**PLANNING COMMISSION
MEETING**
January 9, 2023
4:00 PM

Theresa Cashman
Special Exception
3820 8th Street South
December 30, 2023

N & N Auto Outlet
Site Plan Review
641 Dale Street
January 3, 2023

4) Parking

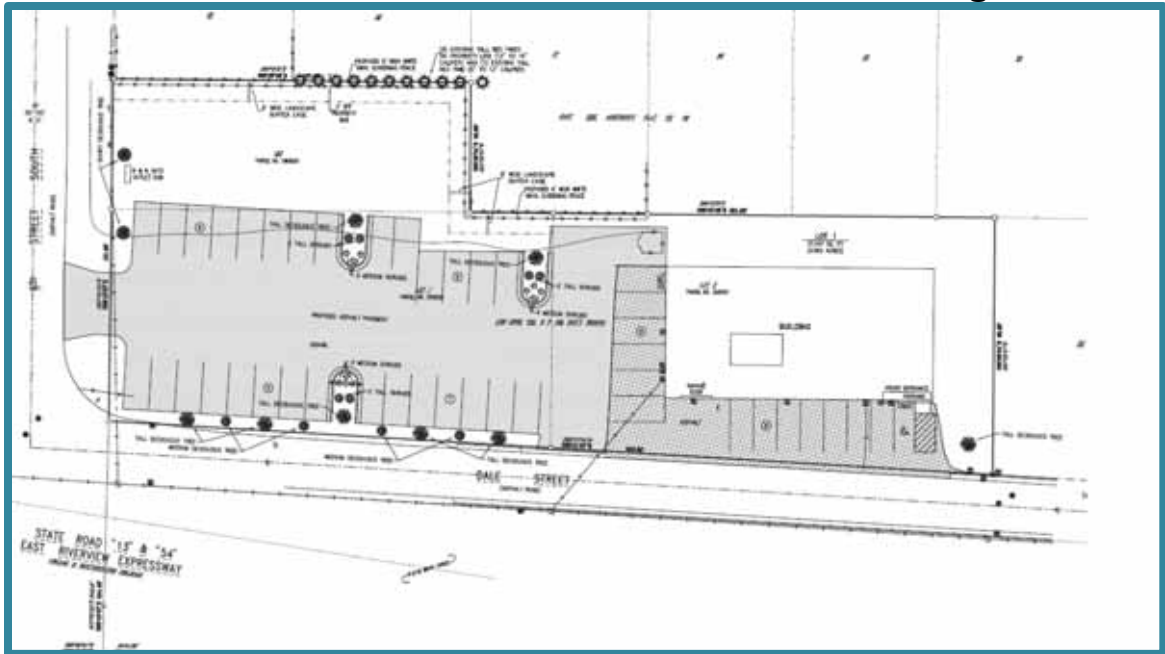
Analysis: The use (vehicle sales and rental) requires 1 parking space for each 300 square feet of gross floor area, plus 1 space for each employee on the largest work shift (17 plus 3 employee for 20 total). Projects that require between 1 and 25 parking spaces require 1 ADA approved accessible parking space. In the B-2 District, no more than 35% of the on-site parking can be located between the street and the building, Plan Commission can grant a special exception to allow up to 50%.

Findings: The applicant is proposing a total of 42 parking spaces plus 1 ADA approved accessible space. This meets the minimum parking requirement and provides extra parking for the display vehicles. Because the supplemental standards require that display areas and activity areas be located at least 30 feet from properties in residential zoning districts, a condition of approval has been added that the six spaces in the north central portion of the lot be marked for employee parking only.

For new development, no more than 35% of parking shall exist in front of the building, but Planning Commission can approve up to 50%. However, as the building is existing and the parking improvements are within an expanded lot area, this section would not apply. Furthermore, the corner lot creates a uniqueness on the elongated site where a side yard along 6th Street is then created.
